Sun SPARC Enterprise T5120 and T5220 Servers

Product Notes

Part No.: E21877-04
December 2011

Hard Drives Can Be Difficult to Remove From Right-Side Drive Bays

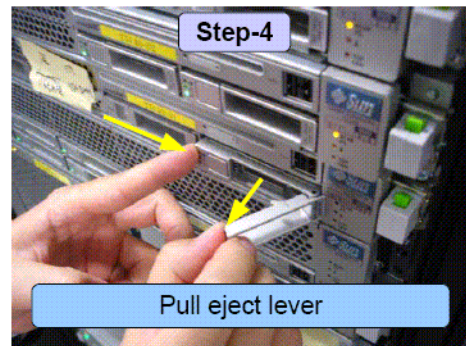
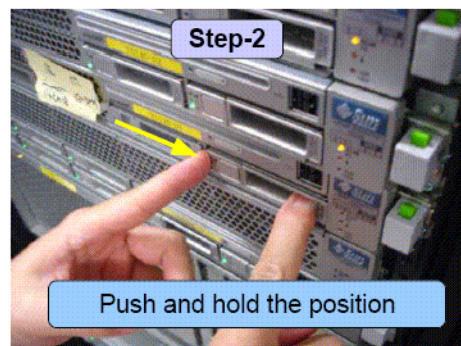
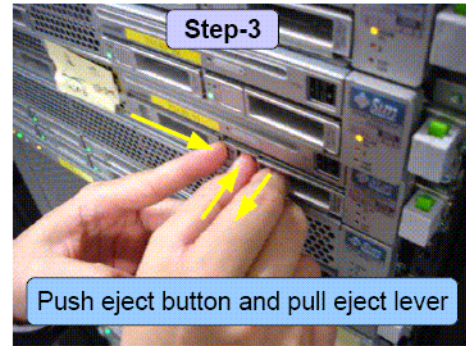
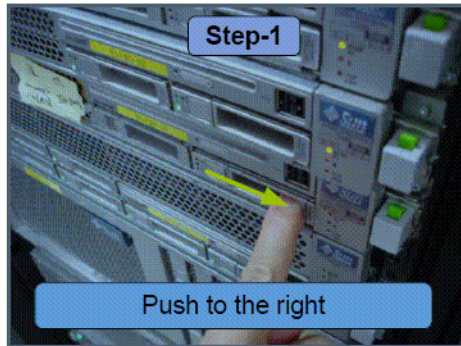
Hard drives in the right-side drive bays can be difficult to remove.

1. Press the drive to the right.
See *Step 1* in the following figure.
2. Push in on the drive, while holding it pressed to the right.
See *Step 2* in the following figure.

3. Press the drive eject button and pull on the eject lever.
See *Step 3* in the following figure.

4. Use the eject lever to slide the drive out of the bay.
See *Step 4* in the following figure.

FIGURE 0-1 Hard Drive Data Cable Routing for SAS RAID Controller Card in 8-Disk Capable Sun SPARC Enterprise T5120 Servers

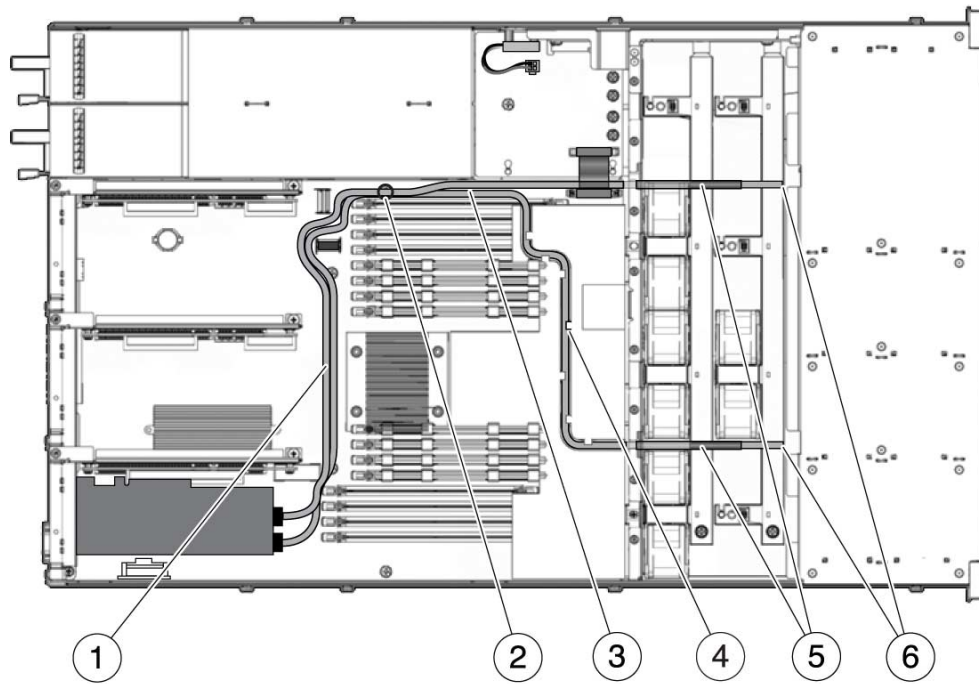
The *SPARC Enterprise T5120 and T5220 Servers Service Manual* contains incorrect descriptions of data cable routing between SAS RAID HBA ports and 8- or 16-disk capable backplanes.

Currently, the CN0 and CN1 port connections are the opposite of what they should be. The following list describes the correct SAS data cable connections and provides illustrations of the correct cable routing:

- CN0 <--> P2 (J0301)
- CN1 <--> P3 (J0302)
- [FIGURE 0-1](#) in this manual shows the correct cable routing information for eight-disk capable T5120 servers. Use it in place of the figure shown on page 194 of the Service Manual.
- [FIGURE 0-2](#) in this manual shows the correct cable routing information for eight-disk capable T5220 servers. Use it in place of the figure shown on page 207 of the Service Manual.

FIGURE: Removing FB-DIMMs

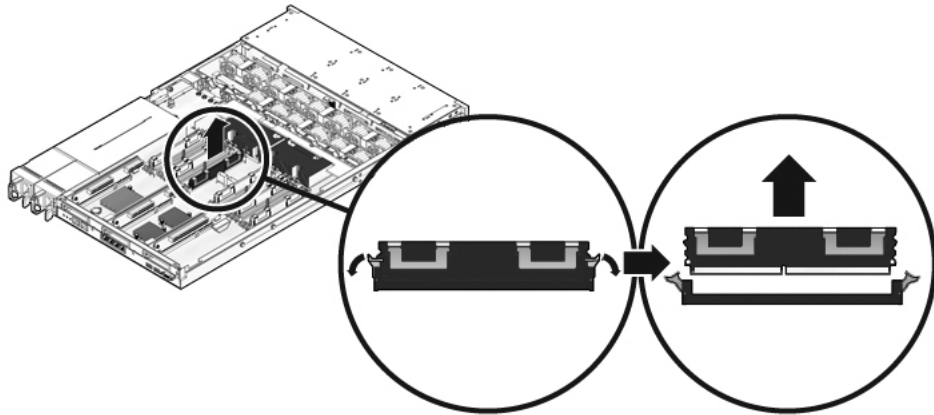
Corrected FB-DIMM Removal Procedure

7. **Push down on the ejector tabs on each side of the FB-DIMM until the FB-DIMM is released.**

8. Grasp the top corners of the faulty FB-DIMM and lift it out of its slot.
9. Place the FB-DIMM on an antistatic mat.
10. Repeat [Step 7](#) through [Step 9](#) for any other FB-DIMMs you intend to remove.
